Response to
Request for Additional Information No. 248, Supplement 3

U.S. EPR Standard Design Certification
AREVA NP Inc.
Docket No. 52-020
SRP Section: 03.04.02 - Analysis Procedures
SRP Section: 03.07.01 - Seismic Design Parameters
SRP Section: 03.07.02 - Seismic System Analysis
SRP Section: 03.08.01 - Concrete Containment
SRP Section: 03.08.03 - Concrete and Steel Internal Structures of Steel or
Concrete Containments
SRP Section: 03.08.04 - Other Seismic Category I Structures

Application Section: FSAR Ch 3

QUESTIONS for Structural Engineering Branch 2 (ESBWR/ABWR Projects) (SEB2)

References

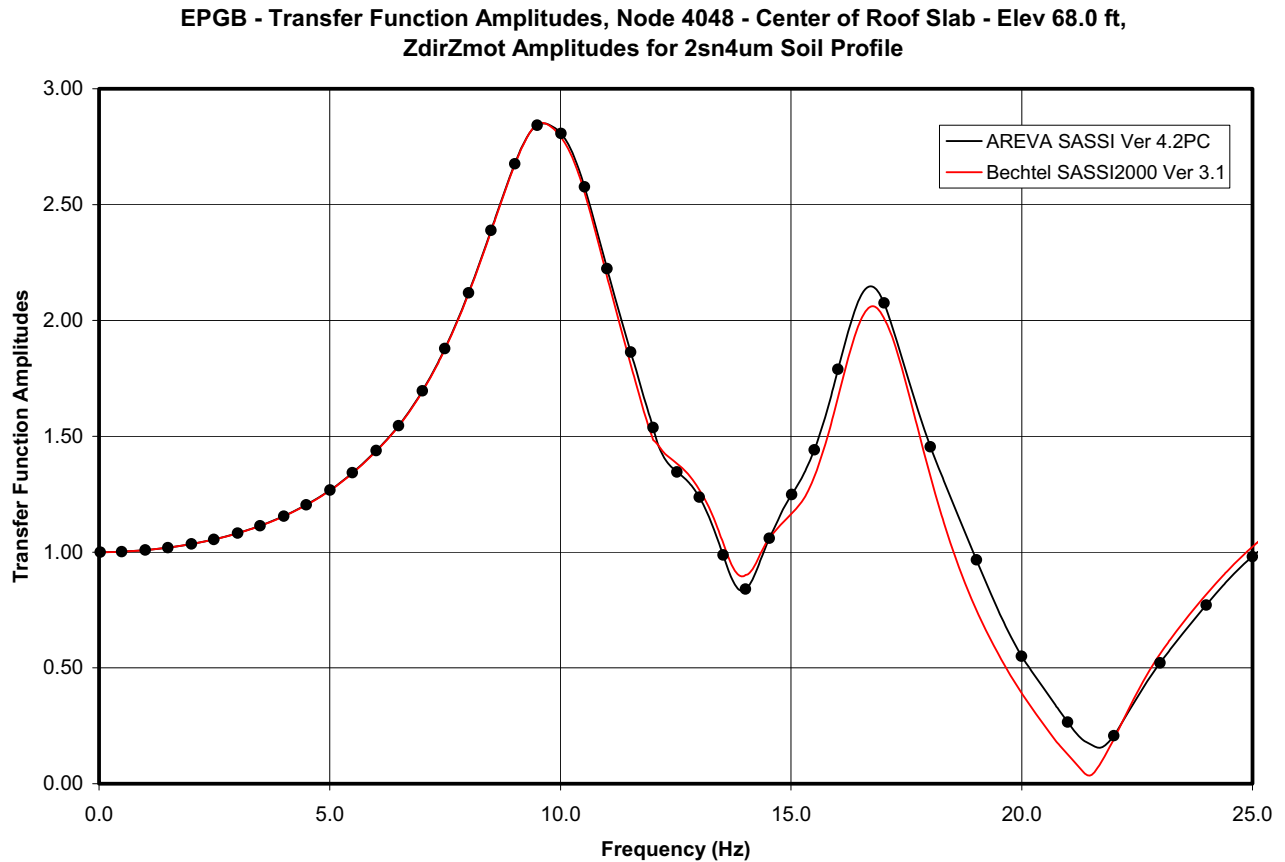
The response states that the two versions of the code are functionally the same and produce equivalent results with no significant differences. However, it does not provide a comparison of results from a building seismic analysis using the two versions (AREVA SASSI v. 4.1B and Bechtel SASSI2000, v. 3.1) as requested in Question 03.07.02-1. Because each code is being used in the analysis of Seismic Category I structures, it should be demonstrated that the codes provide similar results for the SSI analysis. The applicant is requested to run an analysis of an embedded seismic Category I structure using both versions of the code and demonstrate that the seismic response of the structure is similar for each of the programs.

Figures 3.7.2-43-5 through 3.7.2-43-13 show the transfer function comparisons in the three directions for the above nodes. The results show that the seismic response of the structure is comparable for each of the programs.

**Figure 03.07.02-44-1—Design Response Spectra for EUR Control Motions
(hard, medium, soft sites) and Bell Bend Nuclear Power Plant Site –
Horizontal and Vertical Directions, 5% Damping**

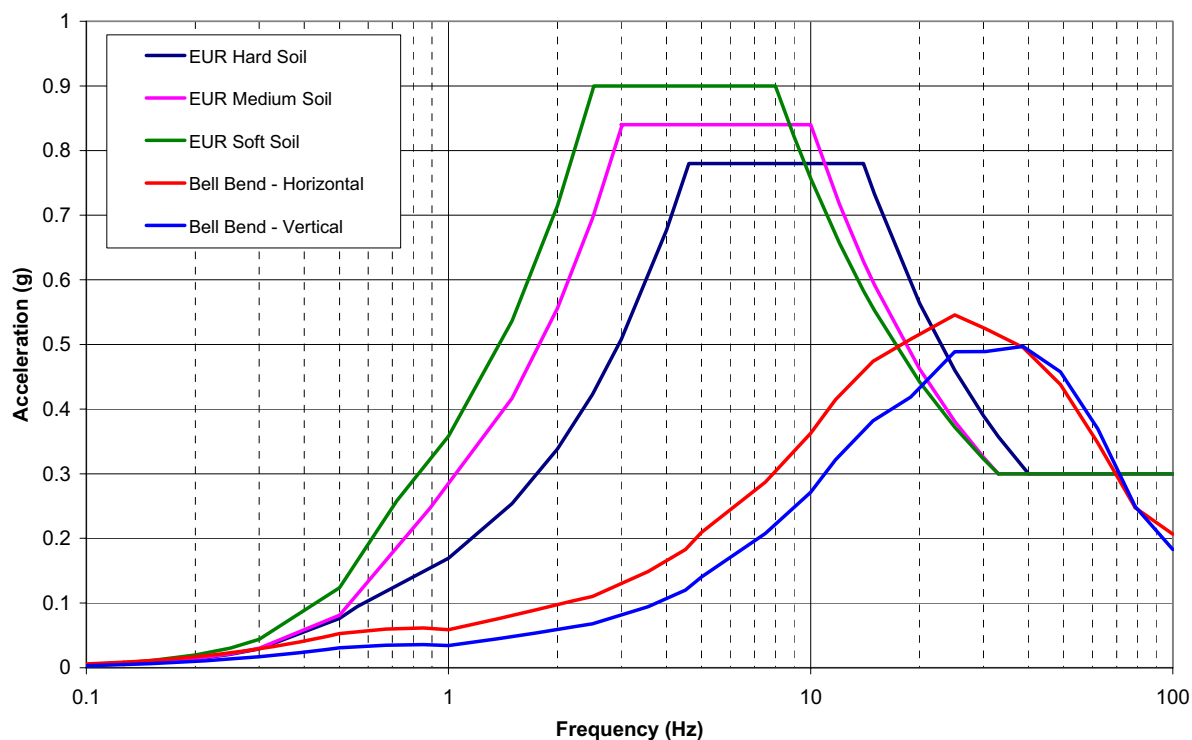
The response does not adequately address the question which asked for the frequency transmission characteristics of the stick model as well as the FEMs used for seismic analysis. In reviewing the modal frequencies of the stick models, it is noted that for the balance of NI Common Basemat Structures, the Reactor Containment Building, and the Reactor Building Internal Structure, the highest reported frequencies as reported in FSAR Tables 3.7.2-1, 3.7.2-2, and 3.7.2-3 are 28.65 Hz, 34.98 Hz, and 35.44 Hz, respectively. As such, these models may not be appropriate for many Eastern U.S. sites where earthquakes are characterized by high frequency input. The applicant is requested to add a COL information item that requires the COL applicant to determine if the U.S. EPR seismic models are appropriate for use at the COL applicant's site because of the limitation of the seismic models to transmit high frequency input.

The stick model for the NI Common Basemat Structures has been replaced by the finite element model (FEM) which is meshed to capture high frequency response. Additional details on the FEM will be provided in response to RAI 320.

Additionally, the U.S. EPR certified seismic design response spectra (CSDRS) will be revised to include the Bell Bend Nuclear Power Plant (BBNPP) ground motion response spectra (GMRS). The addition of the BBNPP GMRS to the U.S. EPR CSDRS assures that the high frequency input at each of the currently proposed U.S. EPR sites will be enveloped by the CSDRS. Figure 03.07.02-44-1 is provided for reference and shows the new CSDRS including the higher frequency content of the BBNPP curve. The three additional soil SSI analyses cases encompassing the BBNPP GMRS, the site-specific soil profiles (Upper Bound, Best Estimate, and Lower Bound), as well as the FSAR changes associated with the revised CSDRS will be provided in response to RAI 320.

Figure 03.07.02-47-1—In-Structure Response Spectra, Comparison of Simplified EPGB FE Model with Current Mesh and Refined Mesh in Z Direction, Elevation 15.7m, 5% Damping

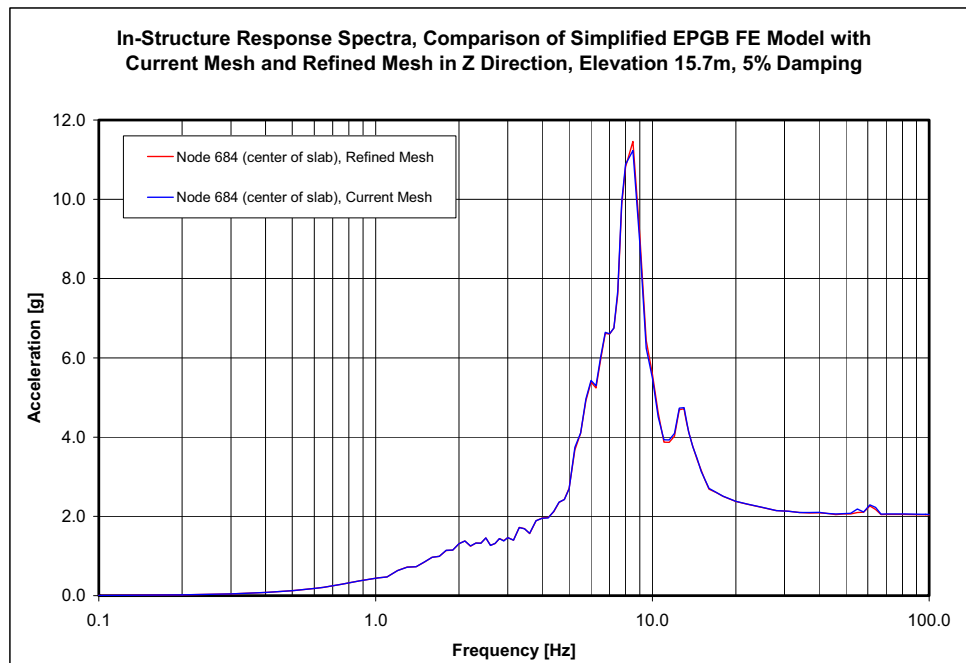
- b. Although the seismic response of the EPGB and ESWB were based on FEMs and not stick models, the applicant is requested to demonstrate that the seismic models for each of these structures is sufficiently detailed that they provide accurate results from the seismic analysis of each of these structures.

- a. The NI Common Basemat Structures stick model has been replaced by a finite element model (FEM). Additional details on the FEM will be provided in response to RAI 320.
- b. The EPGB and ESWB were reanalyzed using a finer mesh (half the size). The comparison between the two models is shown in Figure 03.07.02-47-1 and it can be concluded that the current mesh is acceptable..
